Mesa 500-kV Substation Project CPUC Minor Project Change Form

Report No.: 05

RE: Mesa 500-kV Substation Project – Minor Project Change No. 5 Request: Installation of three new switches

100 ft LWS
 SWITCH POLE #3

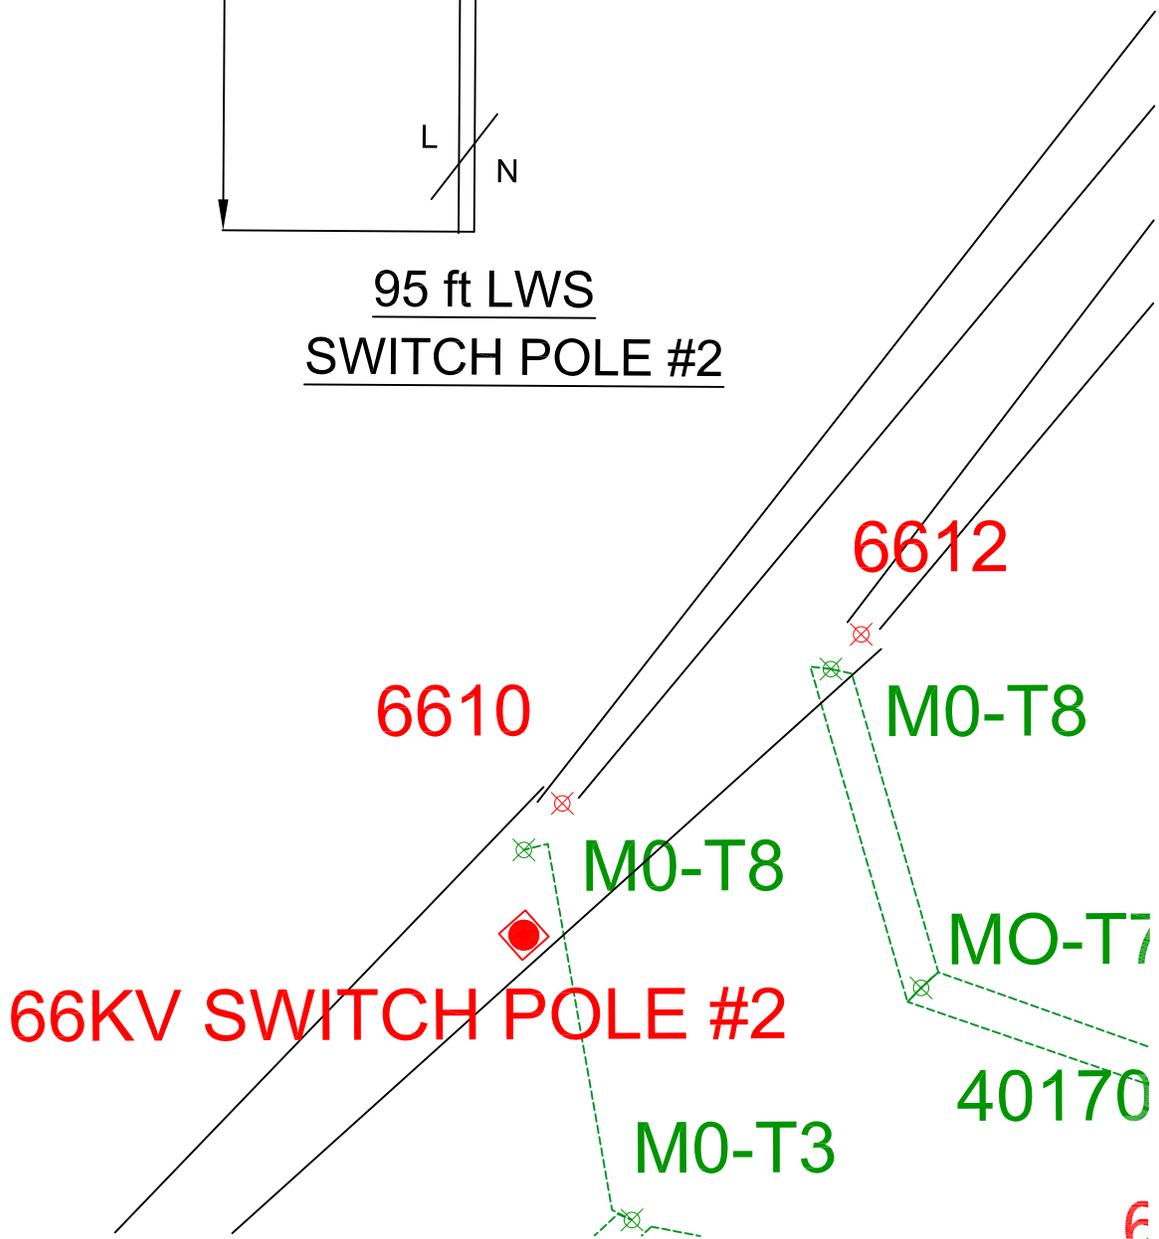
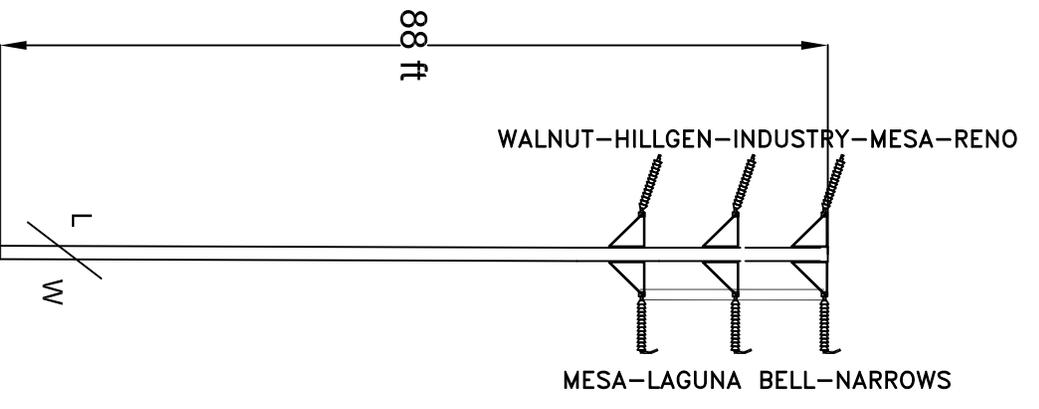
SP 1 and SP 2 would be installed on new poles approximately 79 and 84 feet tall (aboveground), respectively. SP 3 would be installed on a new pole approximately 88 feet tall (aboveground), which would replace the existing Pole 6604 within the same footprint. All three switches and associated poles would be set back more than 50 feet from the nearest public roadway, and would be consistent with the surrounding industrial viewshed. The three new switches would not be expected to substantially degrade the surrounding viewshed.
